**COUNCIL SUBMISSION ON PREFERRED PROJECT REPORT for  
MP10\_0112 being a Concept Plan Application for a Mixed Use Residential  
Development at 110-114 Herring Road, Macquarie Park and MP10\_0113 being a  
Project Application for Stage 1 works (Buildings H, W, C & Y) - Stamford Grand  
Hotel site.**

# **RESPONSE TO PREFERRED PROJECT REPORT FOR MP10\_0112 & MP10\_0113) 110-114 Herring Road, Macquarie Park Concept Plan & Stage 1 Project Application (STAMFORD SITE)**

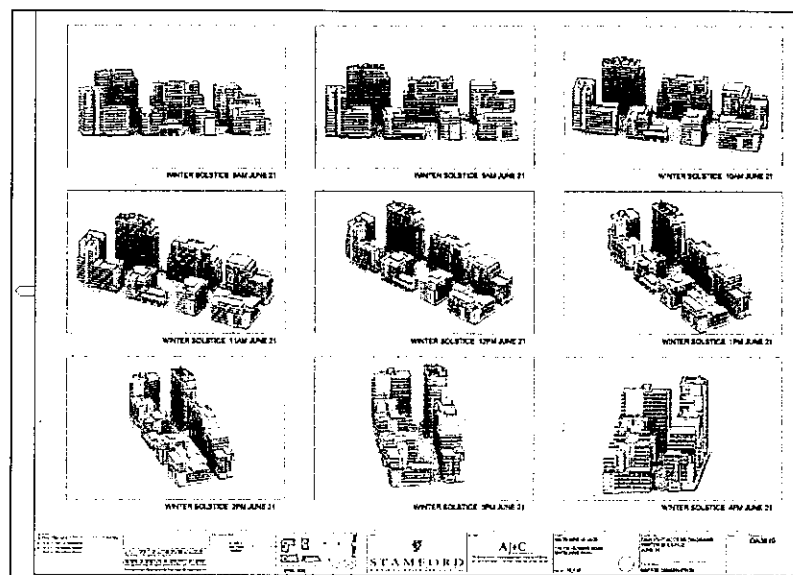
The development appears to rely on stormwater being disposed of over adjoining properties. Council considers that the agreement of the downstream owner for an easement needs to be confirmed prior to approval. The proponent's response that it will be provided at Construction Certificate stage is too late. What happens if the site cannot be appropriately drained? If the proponent is going to rely on a pumped system or other method that does not comply with Council's stormwater policy, Council wishes to be informed prior to any consent being issued. This is particularly the case if Council will be responsible for dealing with a future development application for Stage 2 of the project.
